DRAWN BY: R. Chambers 3/9/12		TITLE	
CHECKED BY: J. Walser 3/9/12		IP65/IP68 Mini40 Transducer	
PROJECT # 110516-2	SHEET 1 OF 1	SCALE 3:2	SIZE B
		DRAWING NUMBER 9230-05-1421	REVISION 03

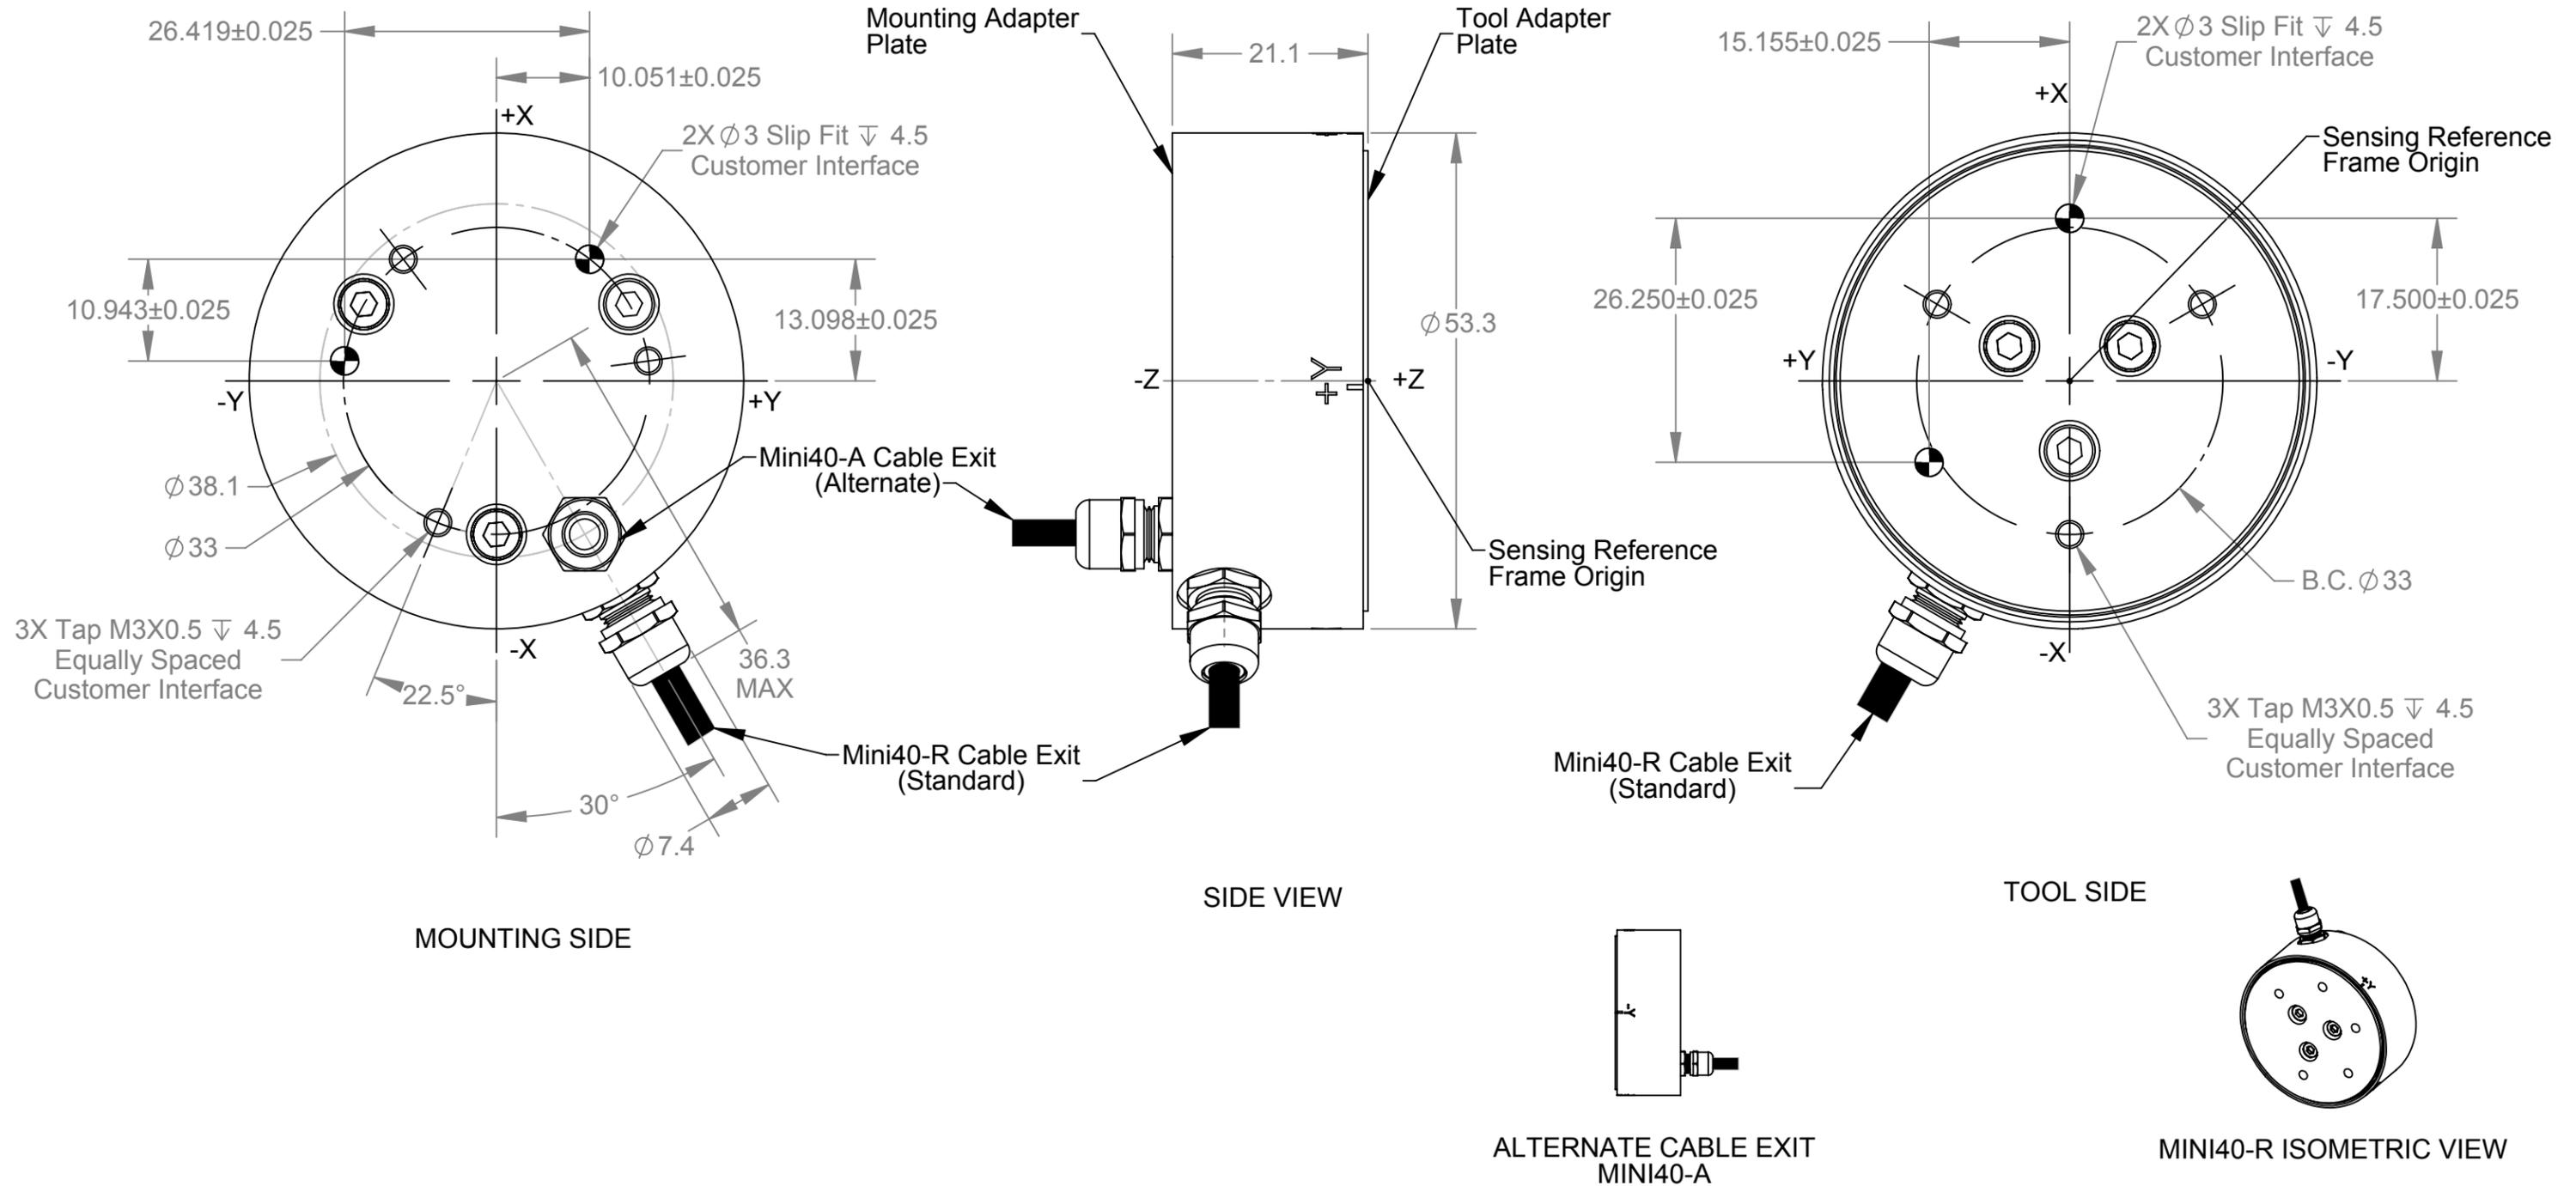
Rev.	Description	Initiator	Date
03	ECO 14323: Increased tolerance on dowel hole positions from ±.013 to ±.025	SZJ	3/28/2016
